Pre-Filed Testimony of K.M. Leytham

**Submitted on behalf of Appellant
Airport Communities Coalition**

**PCHB No. 01-160
*ACC & CASE v. Dept. of Ecology & Port of Seattle***

February 22, 2002

Figure B2-41

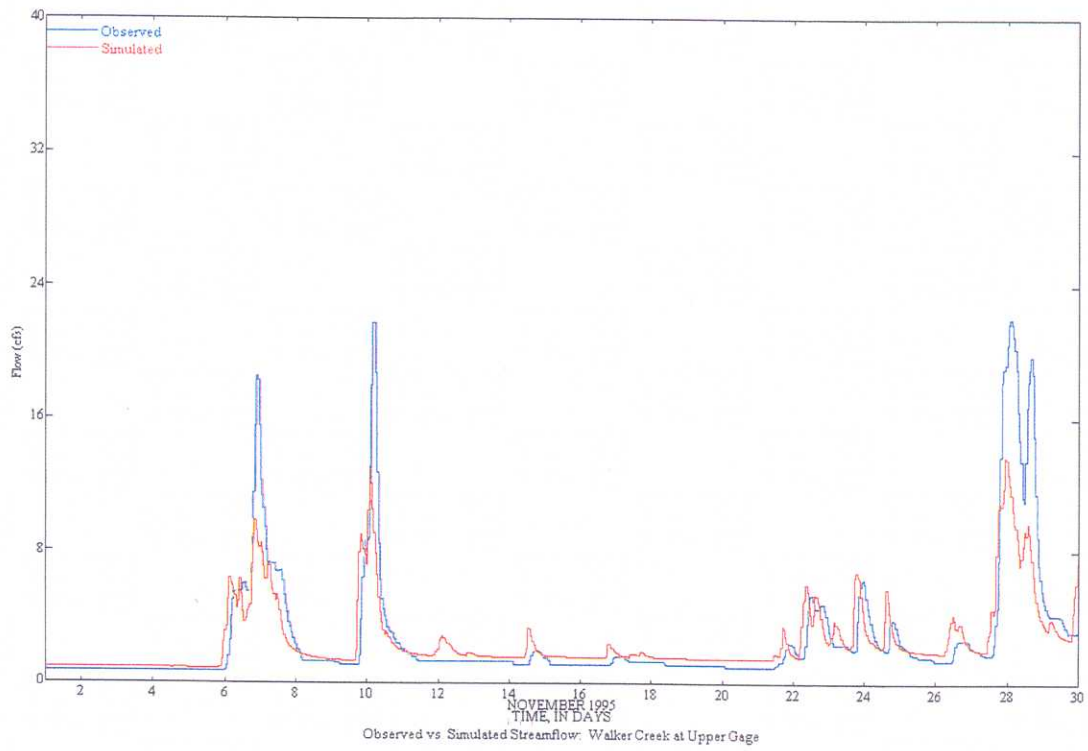
10. A typical example of high flow simulation results for Walker Creek at the Upper Gage for November 1995 is shown in Figure B2-41 of the SMP, a copy of which is attached as **Exhibit B**. The plot shows severe under-simulation of peak flows and flood volumes. These

errors in peak flows and flood volumes are so large and so consistent throughout the calibration period that there appears to be a fundamental problem in the characterization of the hydrologic regime of upper Walker Creek.

**Figure B2-2
 Groundwater
 Flow
 Direction and
 Boundaries**

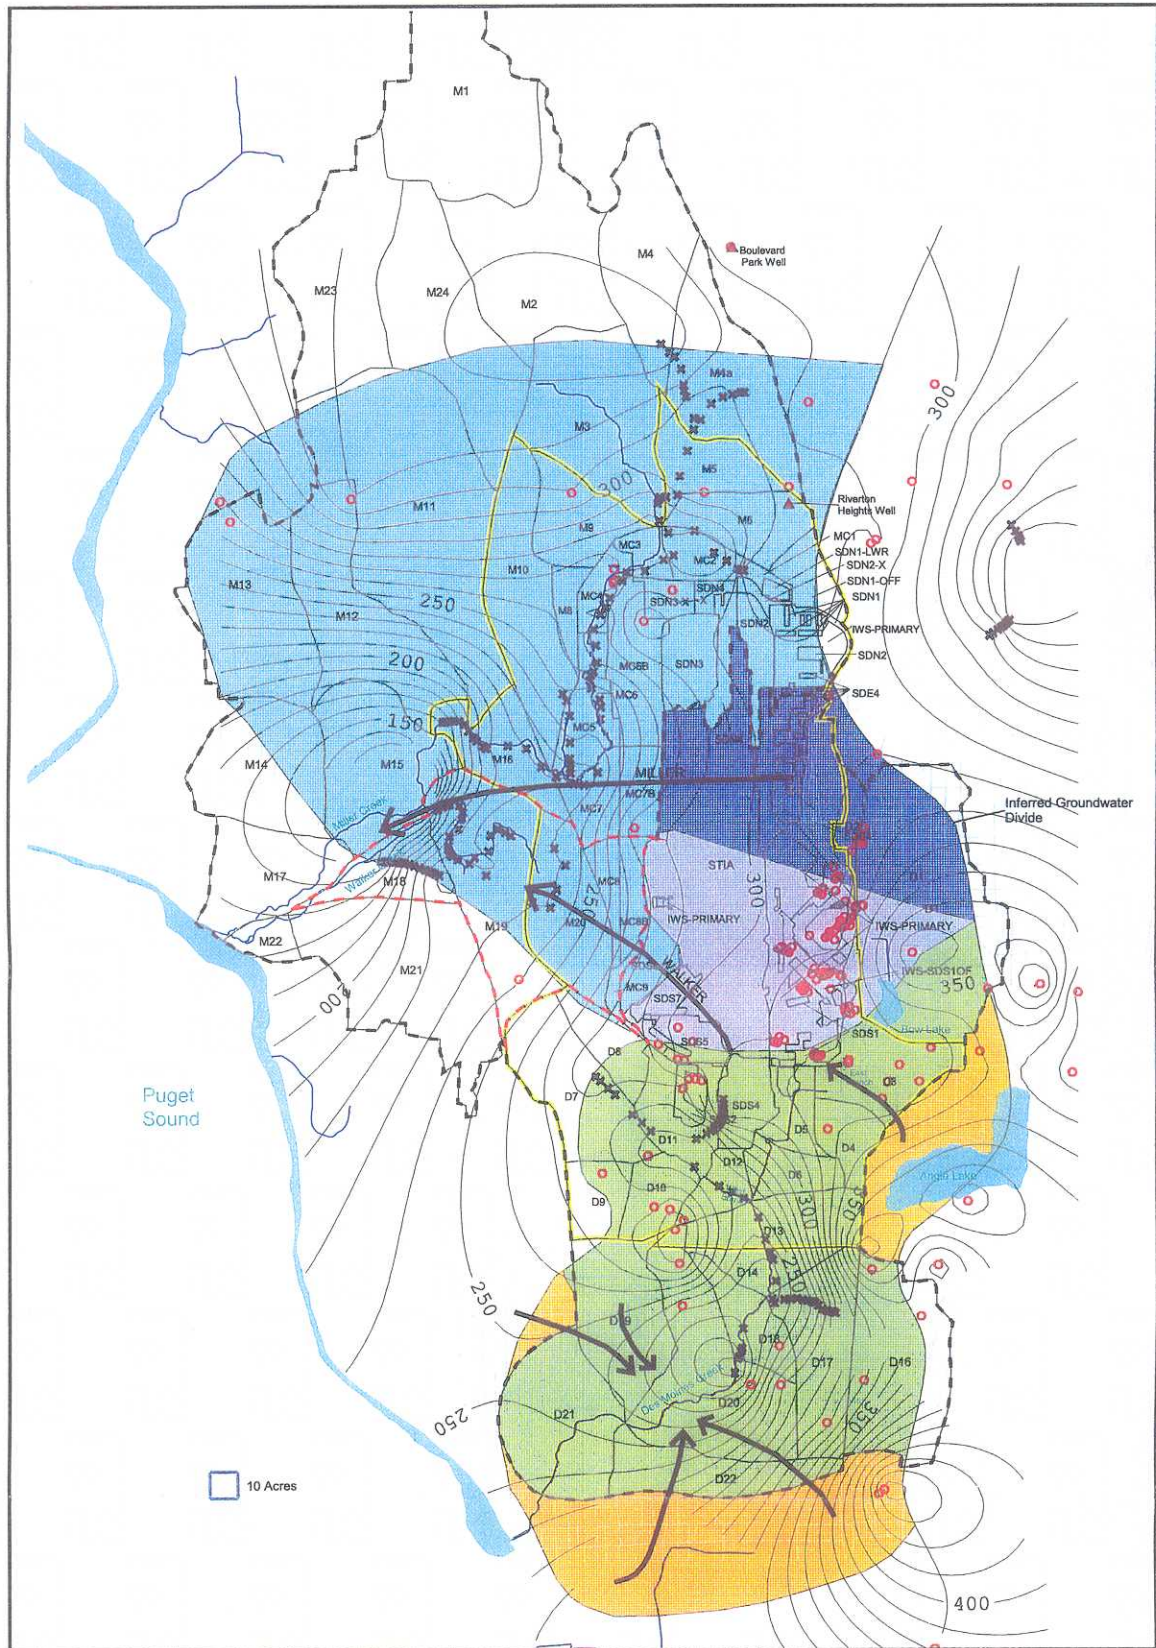
the December 2001 Low Flow Plan, showing a northerly extension of the Walker Creek groundwater basin (**Exhibit D**). This northerly extension of the Walker Creek groundwater basin however seems to be a convenient renaming of the SMP's "noncontiguous Miller Creek groundwater area," depicted in **Exhibit C**. This "re-delineation" of the area contributing groundwater to Walker Creek is inconsistent with the groundwater mapping in **Exhibit C**.

Change between Existing (1994) and Future (2006) Groundwater Basins

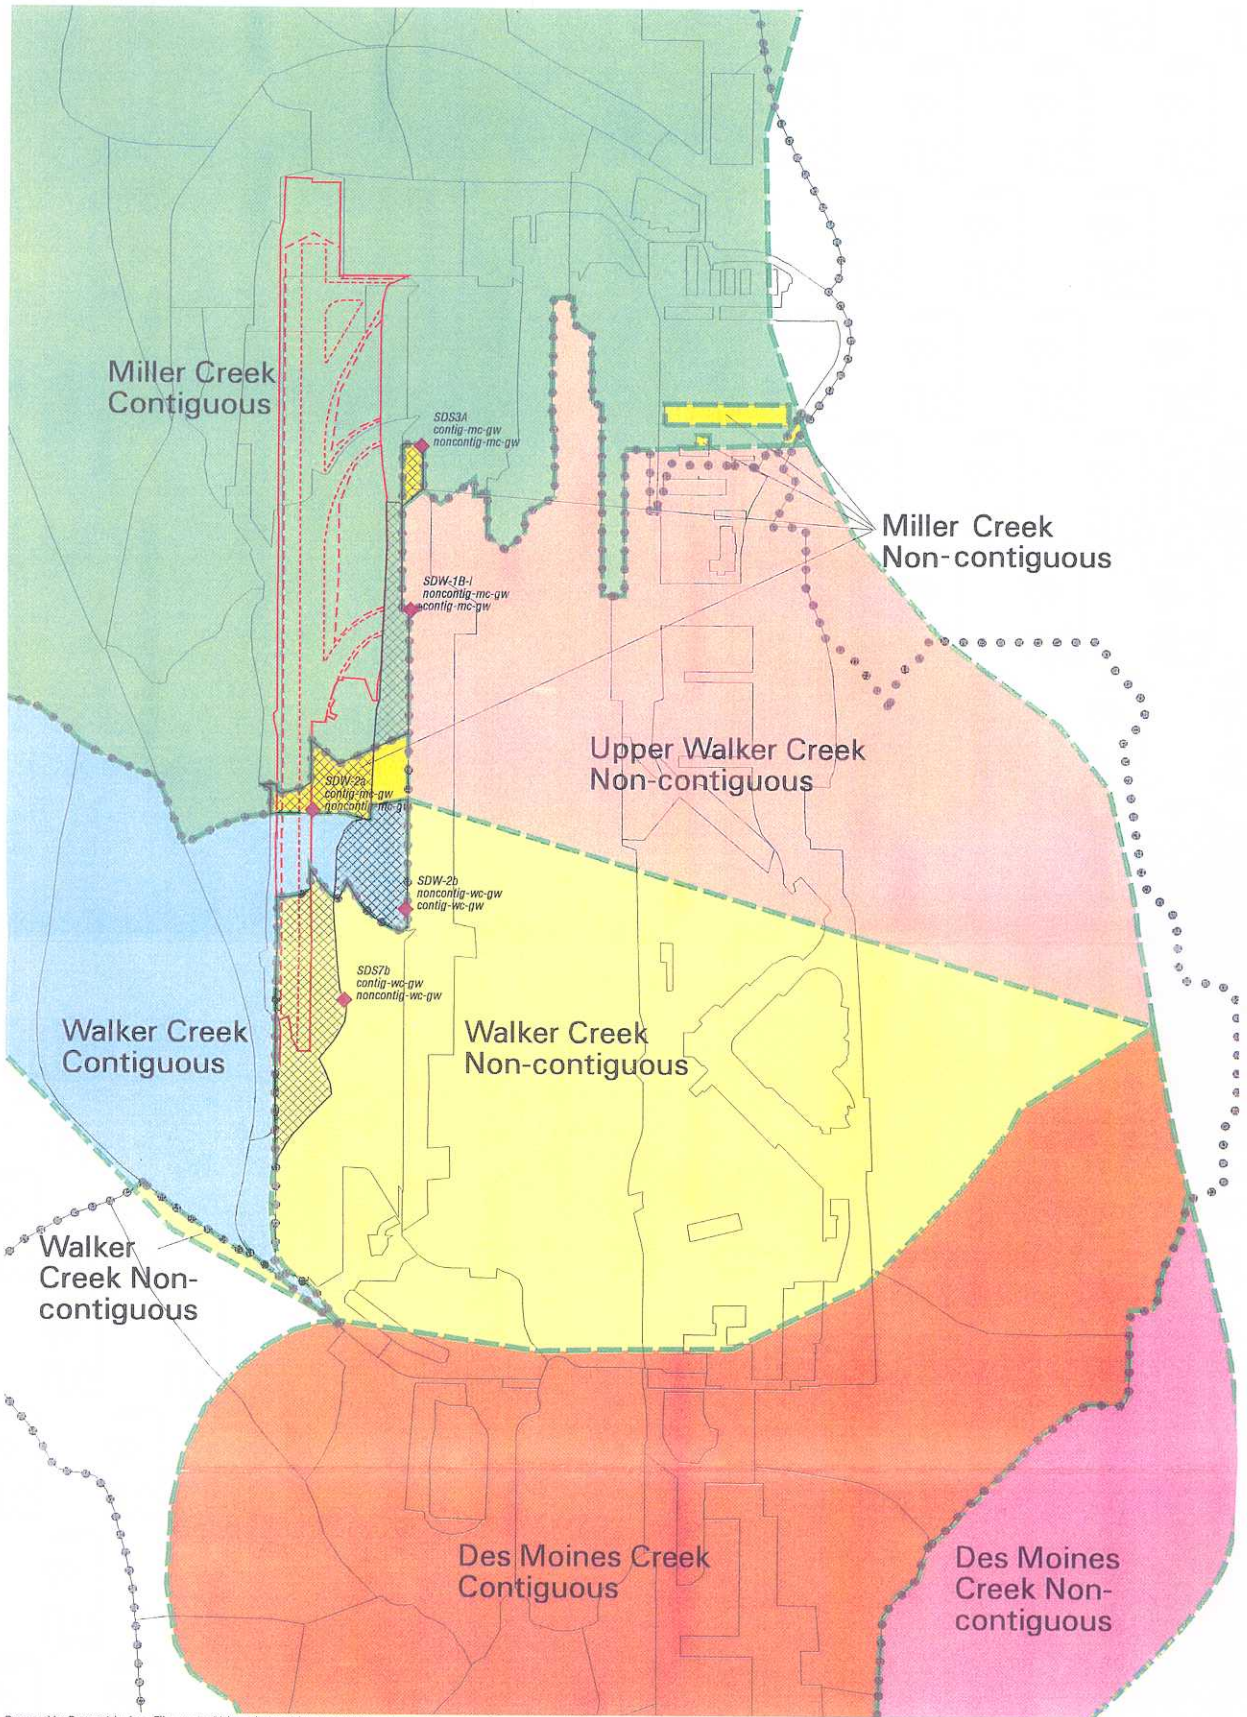
12. That the SMP’s noncontiguous Walker Creek groundwater area may not provide 630 acres of pervious land appears to be recognized in a figure which appears for the first time in

Figure 3-5. Walker Creek Near Wetland Observed vs. Calibrated Low Flow 1991

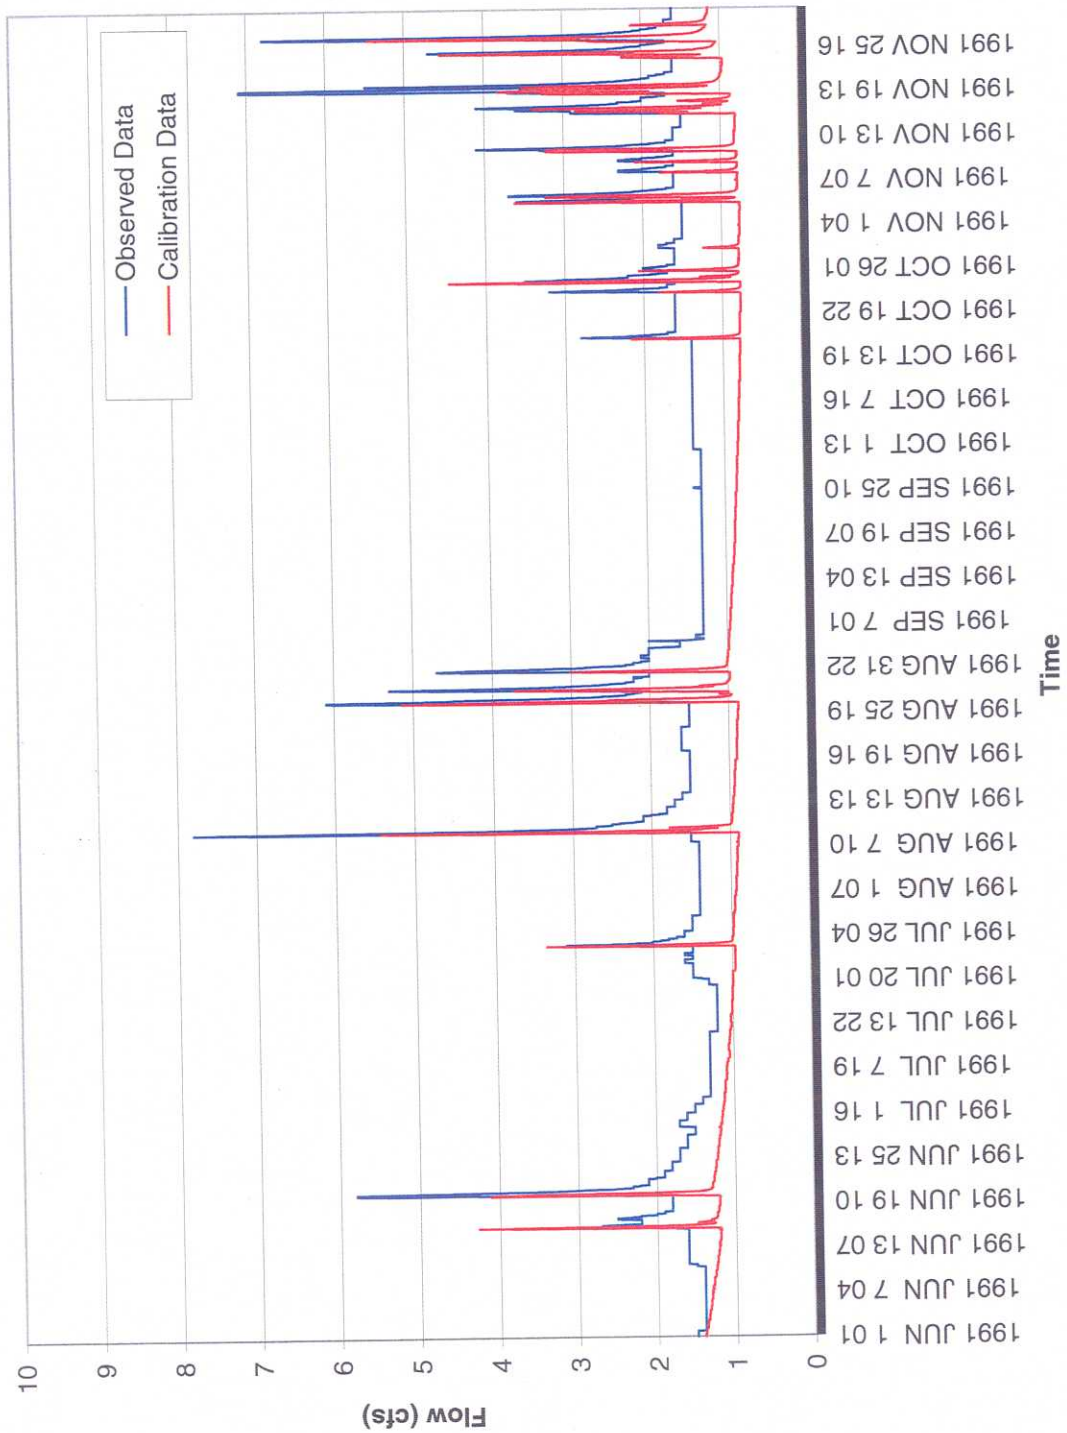
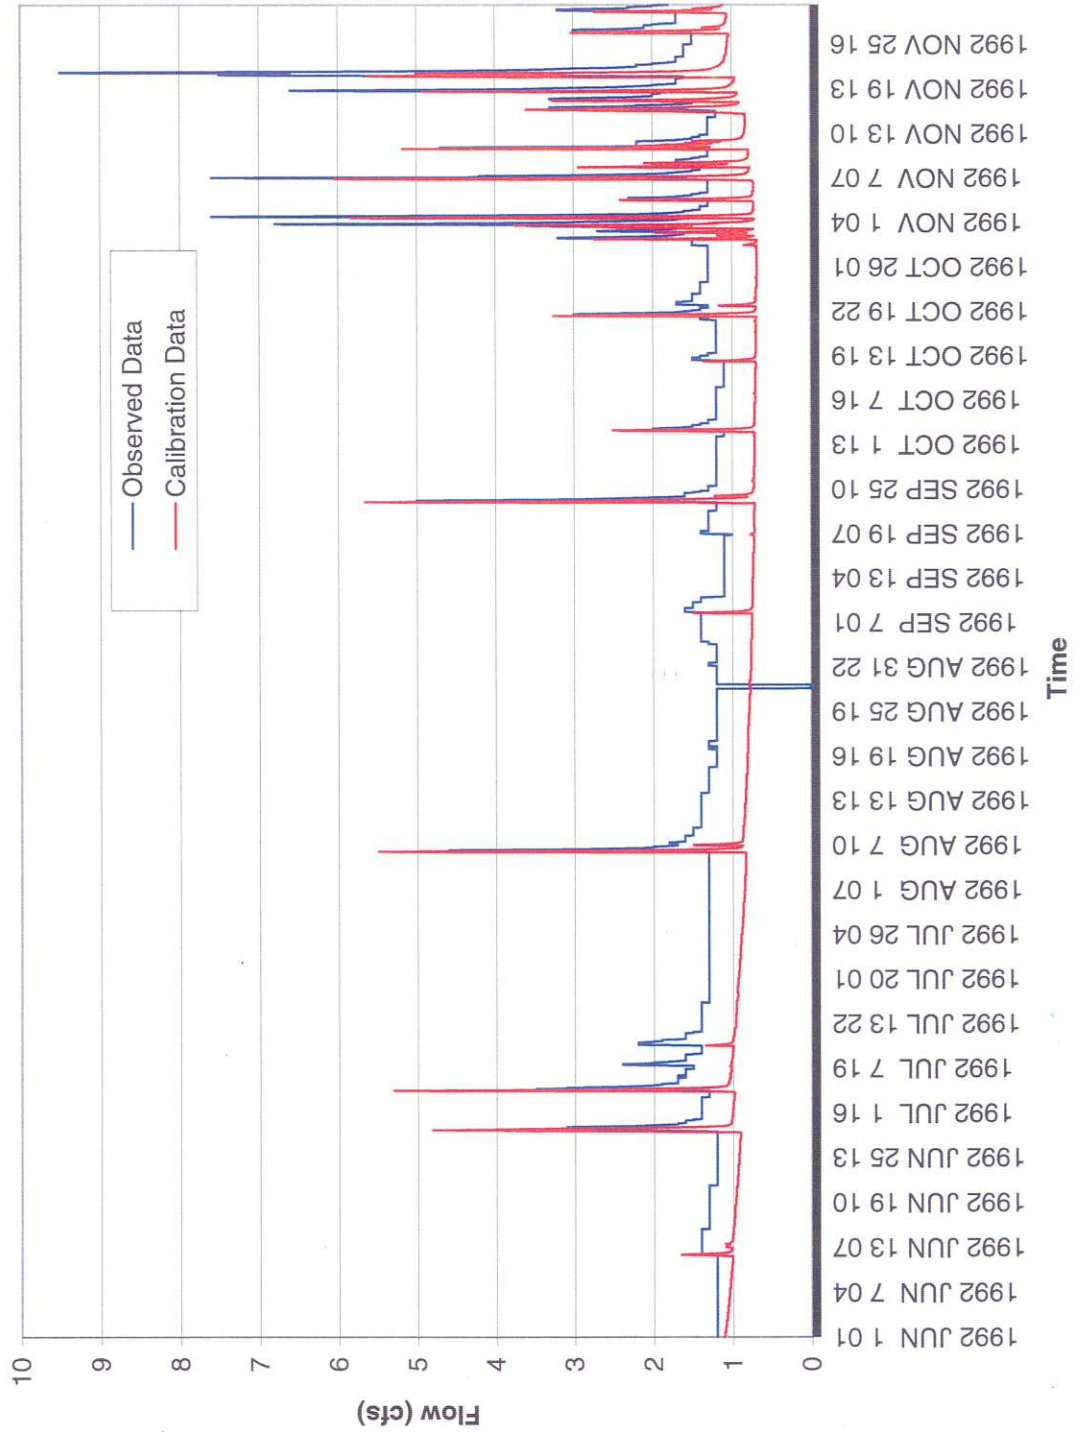
13. The traditional approach to hydrologic model development involves calibration to a certain period of record (in this case water years 1993-1996), followed by model validation, that is, comparison of simulated against observed flows for a period of record that was not used in the model calibration. This has not been done formally for any of the gages used in model calibration, either in Walker, Miller or Des Moines Creek. However, the Port's Low Flow Plan does show a comparison of simulated against observed flows for the Walker Creek Upper Gage for water years 1991 and 1992 for the period June through November. These plots show that low flows are under-simulated by as much as 50% in that period (see Figures 3.5 and 3.6 of the Low Flow Plan, reproduced here as **Exhibit E**).

Figure 4-11. Des Moines Creek at Gage 11c Observed vs. Calibrated Low Flow 1996

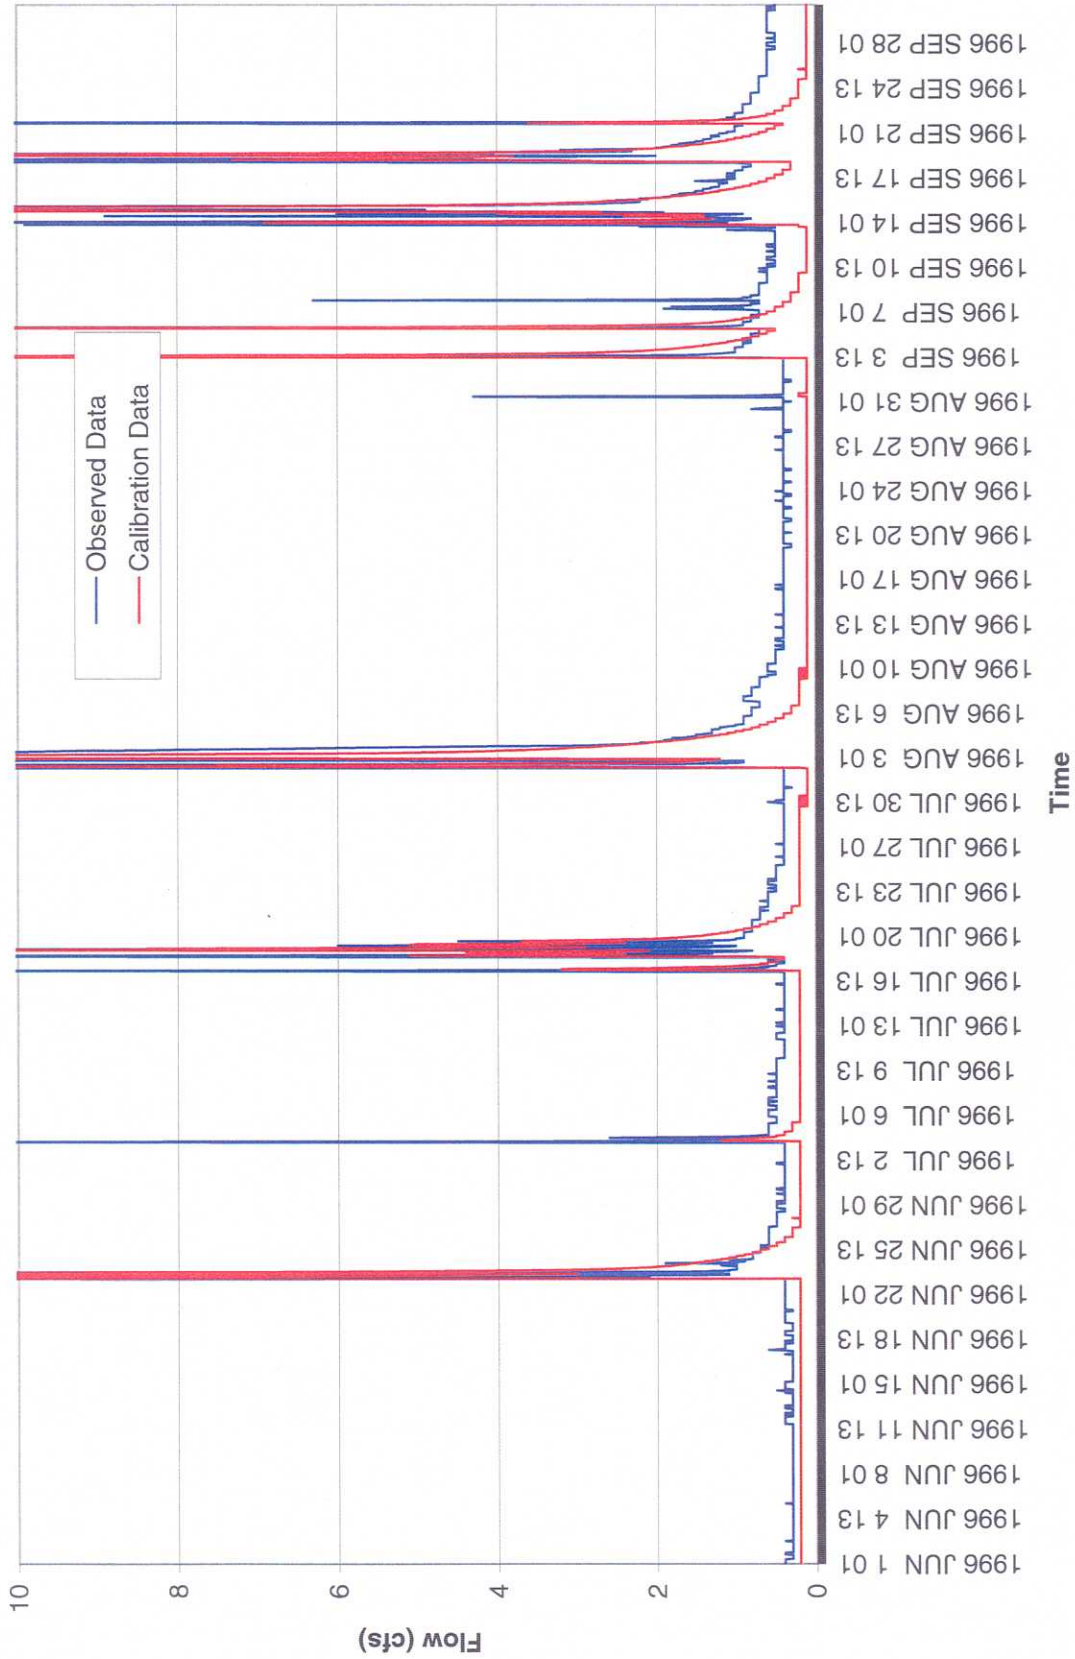
23. Additional model results for low flow periods are provided in the Low Flow Plan. Results for Des Moines Creek at the Mouth are quite variable and as such are difficult to interpret. Low flows at Tyee Pond (King County gage 11c) are however consistently under-simulated. For example, simulated low flows in 1996 are only about one third of the observed flow (Low Flow Plan, Figure 4-11, shown in **Exhibit G**), suggesting a fundamental problem with the characterization of low flows. The deficiencies demonstrate a lack of understanding of the hydrologic regime of the upper Des Moines Creek basin. A better understanding of the hydrologic regime is again needed to reliably identify and quantify project impacts. Without a reliable quantification of project impacts based on a sound understanding of the hydrologic regime, it is not possible to design appropriate mitigation measures. It is also important to note that condition of Water Quality Certification I.1.e.i pertaining to monitoring requires an evaluation of post-project stream gage data against “*expected flow rates established by the model*”, presumably to determine whether project impacts are being satisfactorily mitigated. This is clearly a meaningless condition in a situation such as this where the model’s ability to simulate low flows is so poor.
